INITIAL FIRE SAFETY INSPECTION REPORT

Factory Name: TMSS Apparels Ltd

RSC ID: 24990

Date: 26/12/2023

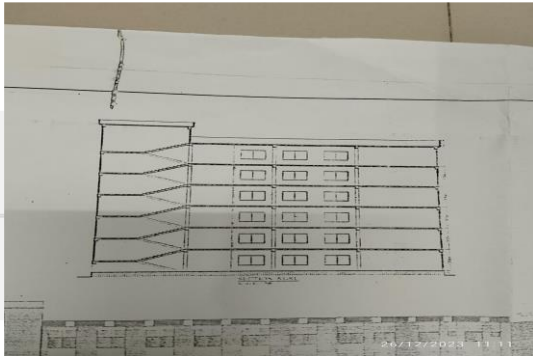
8	Means of Egress	Building did not have stair designation signs and occupant load signs at required locations.	Provide stair designation signs and occupant load signs at required locations.	Within 1 month

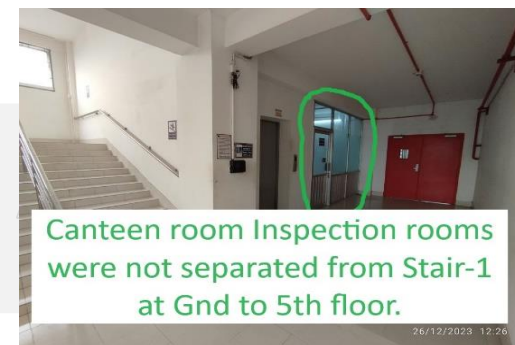
12	Fire Rated Construction	Storage room discharges directly into exit stair enclosure without vestibules. Location : Main Building on 1st floor	Openings from the exit enclosure to the storage room, shall be provided with a vestibule with fire-rated construction and openings. Provide a 1.5 hr. fire-rated door on the exit stair side and a 1 hr. fire-rated door on the store side. Ensure that the fire rating of the vestibule construction matches that of the exit stair enclosure. The minimum width for vestibules shall not be less than 1.1 m and length 1.8 m.	Within 3 months
ADD PHOTO  ADD PHOTO				
13	Egress Lighting	Exit signs were not provided every required exit also some exit signs were not illuminated properly.	Lighted exit signs shall be placed at entrance to an exit. Additional exit signs shall be placed throughout the facility anywhere the continuation of the egress is not obvious. Lighted exit signs shall be provided with either battery backup or uninterruptable power supply systems and shall be continuously illuminated.	Within 1 month

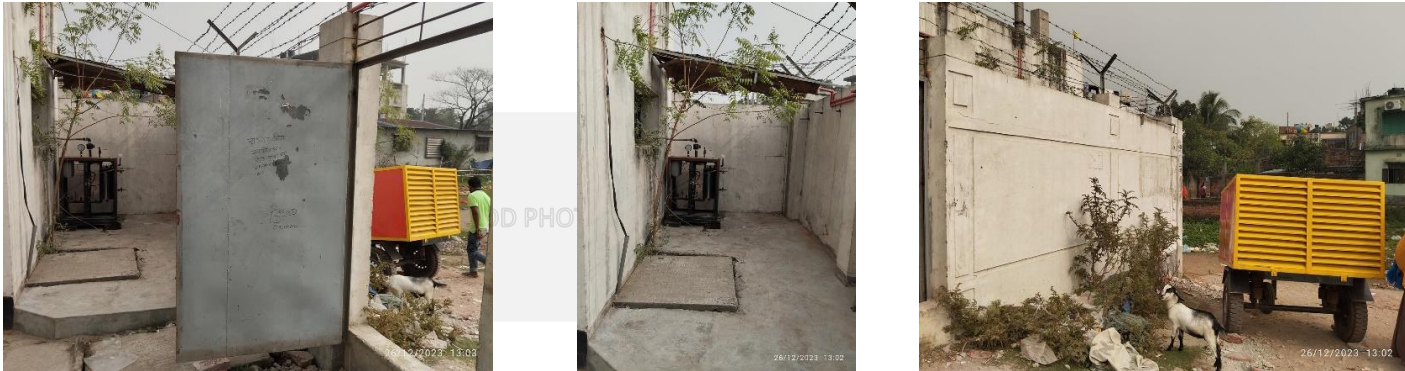
14	Means of Egress	Aisles marks were not provided in the storage room. Location: 1st floor of the Main Building.	Aisles shall be provided with a minimum unobstructed clear-width of 0.9 m (36 in.).	Within 1 month
ADD PHOTO  ADD PHOTO				
15	Means of egress	Minimum handrails height was not maintained at stair 3.	Provide handrails on both sides of the exit stair. New handrails shall have a minimum height of 865 mm (34 in.) and a maximum height of 965 mm (38 in.) as measured from the leading edge of the tread. Intermediate handrails shall be provided when the stair width exceeds 2.2 m (87 in.)	Within 2 months
